**Re: Inland Kenworth, 7711 Fortuna Rd. NW**  
**Certificate of Occupancy – Transportation Development**  
Administrative Amendment dated 09-17-13 (J10-D044)  
Certification dated 07-16-14

**Re: Inland Kenworth, Grading and Drainage Plan**  
**Engineer's Stamp 6-18-13 (J10/D044)**

**Re: Inland Kenworth, Grading and Drainage Plan**  
**Engineer's Stamp 5-29-13 (J10/D044)**

SUPPLEMENTAL/AMENDED INFORMATION  
TO DRAINAGE REPORT  
DATED APRIL 23, 2013

West Storm  
Drain

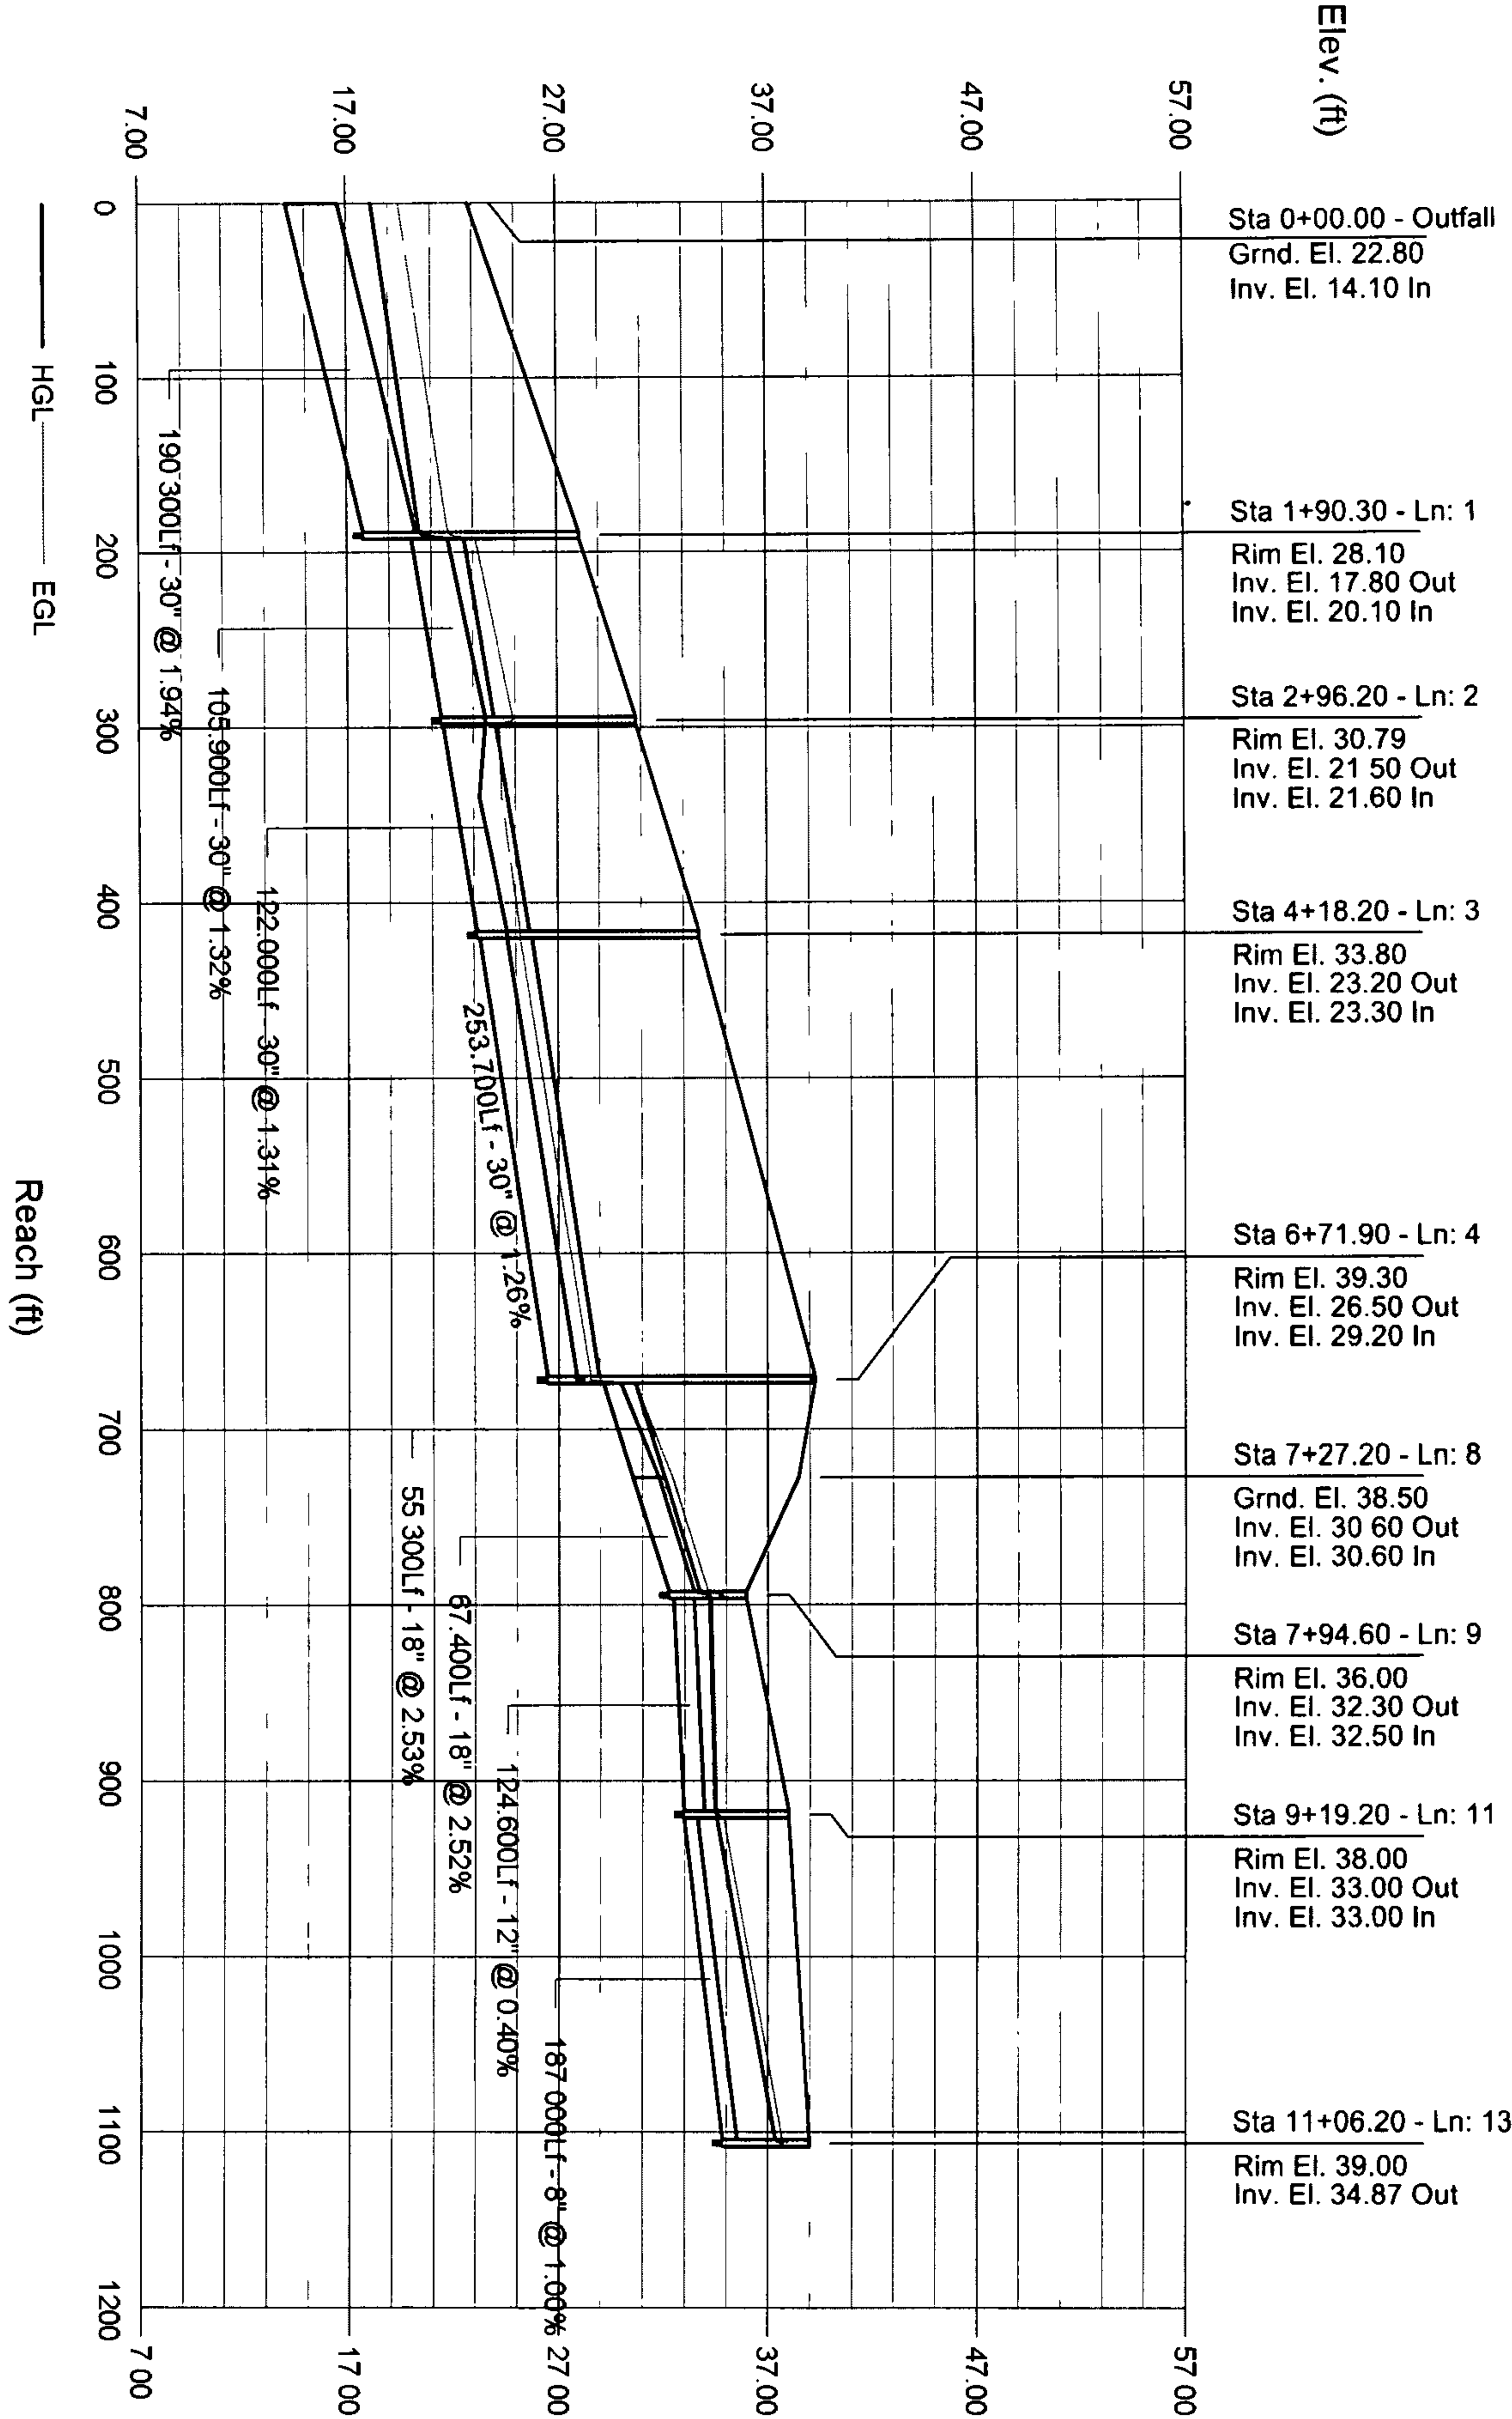
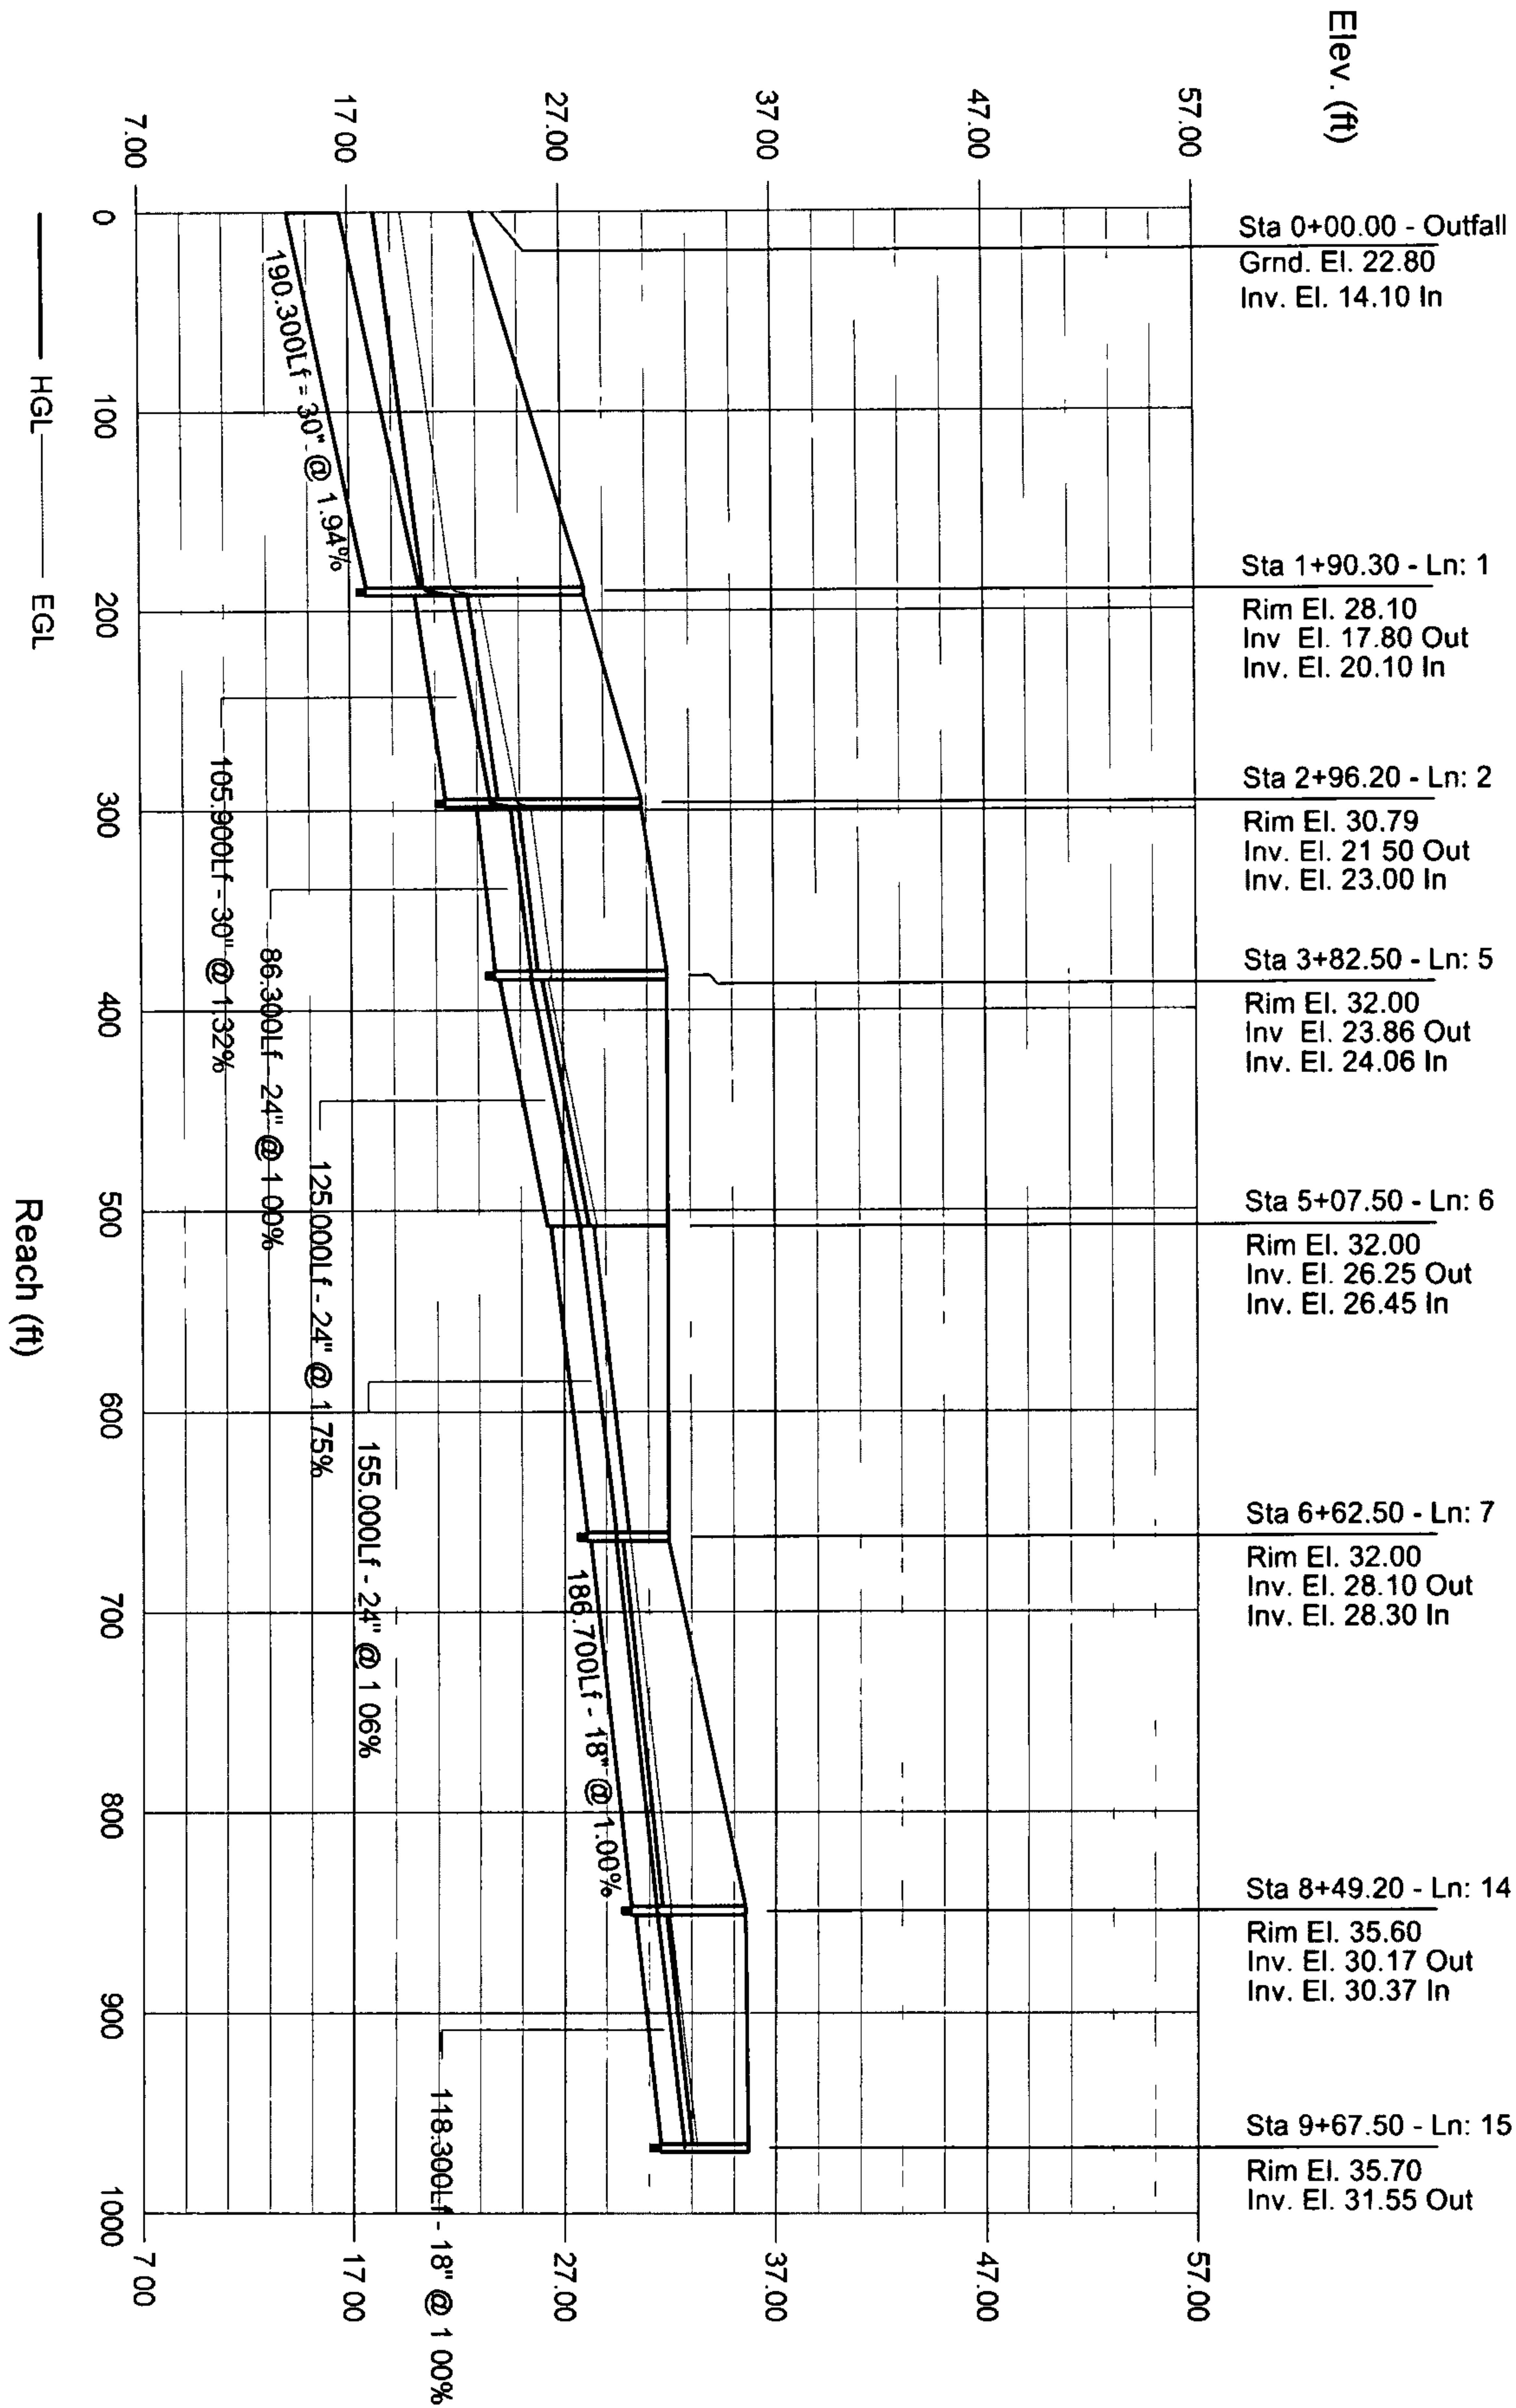
1. Per the DPM, p. 22-106, where the peak flow in the proposed lateral exceeds 10 percent of the main line, the angle of confluence should not exceed 30 degrees. This can be worked out at DRC.
2. Provide calculations for the "D" inlets assuming a 50% clogging factor.
3. Flows from Basin 2 may have difficulty turning 90 degrees as they enter the channel at the northern end. Improving this entry point should help maintain flow in the channel.
4. Provide calculations to support the sizing of the channel draining Basin 2.

1. The storm drain has been revised to provide a max. 30 degree angle of confluence—see attached grading plan and storm drain calculations.
2. Capacity calculations for inlets are included.
3. Channel has been eliminated and replaced with 2- Type C inlets and storm drain.
4. Channel has been eliminated.

- 6) Storm drain sizes have been added to the plan—see sheet CG-103 for details.
- 7) There is a small stilling basin at the outlet of the culverts at the northwest corner of the site. Inverts of the culverts are 33.4 and 33.6, and storm water will overflow to the drainage swale in the NMDOT easement at an elevation of 34.
- 8) Drainage calculations on grading plan were incorrect. Calculations included in approved drainage report dated April 23, 2013 are correct showing 32.2 cfs discharging from site which is less than the 33.3 cfs allowable.
